**BSR/ASHRAE Addendum d
to ANSI/ASHRAE Standard 62.2-2025**

**Proposed Addendum d to
Standard 62.2-2025, Ventilation and
Acceptable Indoor Air Quality in
Residential Buildings**

**First Public Review (April 2026)
(Draft shows Proposed Changes to Current Standard)**

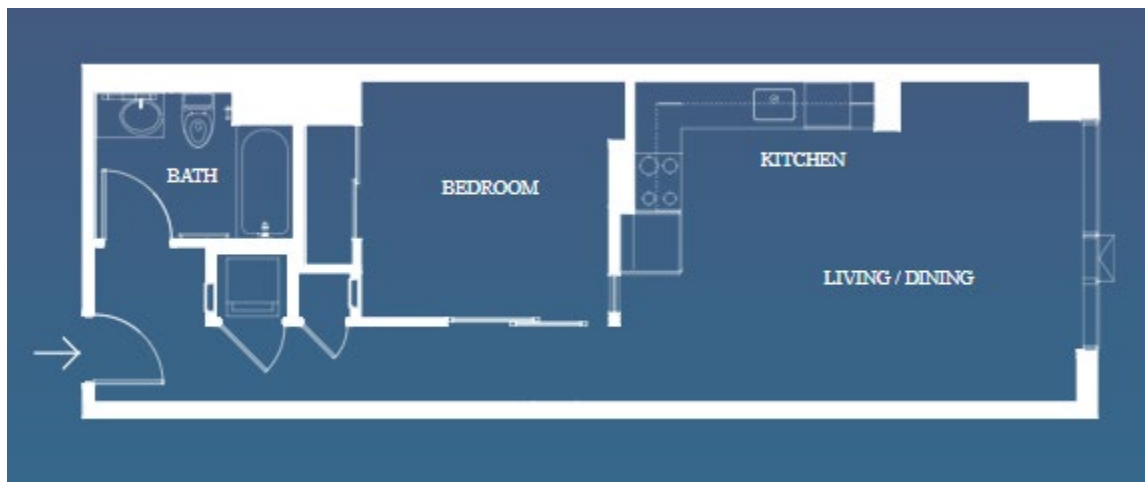
See the floorplan below for unit 1409. The bedroom is entirely interior (does not have a window). Currently, ASHRAE 62.2-2022 allows this configuration without direct ventilation to the bedroom. This proposal would require that ventilation be provided to the bedroom.
